# **CONNECTION ASSESSMENT & APPROVAL PROCESS**

## ***PRELIMINARY ASSESSMENT REPORT***

*For Phase I of the Proposed Development near Tilbury by AGSTAR Power Inc.*

*CAA ID No. 2000-023:*

**DIAGRAM 12**

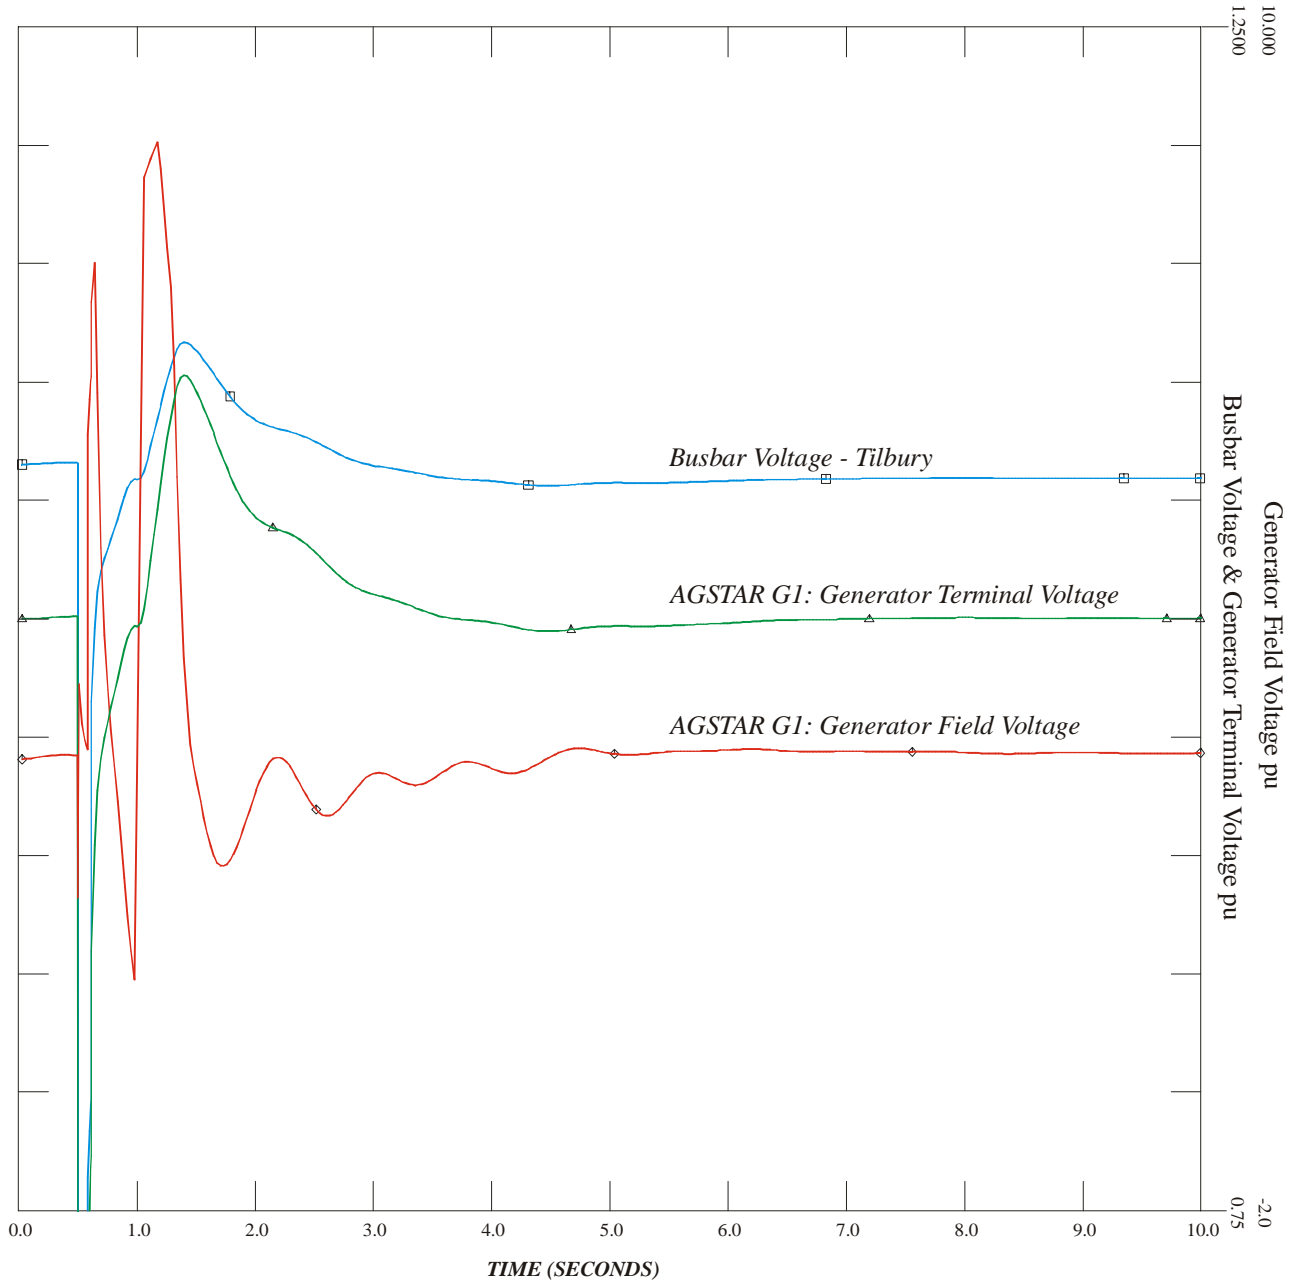
However, from the response curves shown in Diagram 12 (for Study 2: corresponding to a three-phase fault on circuit K6Z at Tilbury), it would appear that the exciter initially produces an increase in the generator field voltage that is either insufficient in magnitude or is not maintained for a long enough interval. Although the exciter subsequently increases the generator field voltage and maintains it at the new value for a longer interval, it appears to over-compensate, resulting in transient over-voltages at the terminals of the AGSTAR generating unit of 10% for normally-cleared faults and 13% for the delayed-clearance conditions.

After approximately 1 second from the time that the fault was imposed initially, the generator field voltage was returned to a level close to its original pre-fault value, where it remained. The terminal voltage at the generator was eventually restored to 1 pu approximately 3 seconds after the maximum value occurred. The 115kV busbar at Tilbury West DS experienced an over-voltage of between 6% & 8%.

The net result of this response was a slow return of the generator angle to its revised steady-state operating value following the switching operations necessary to isolate the fault.

It is therefore a requirement of the IMO that further transient stability studies be performed once the equipment design is finalised and more definite data are available, to confirm the acceptability of the transient performance.
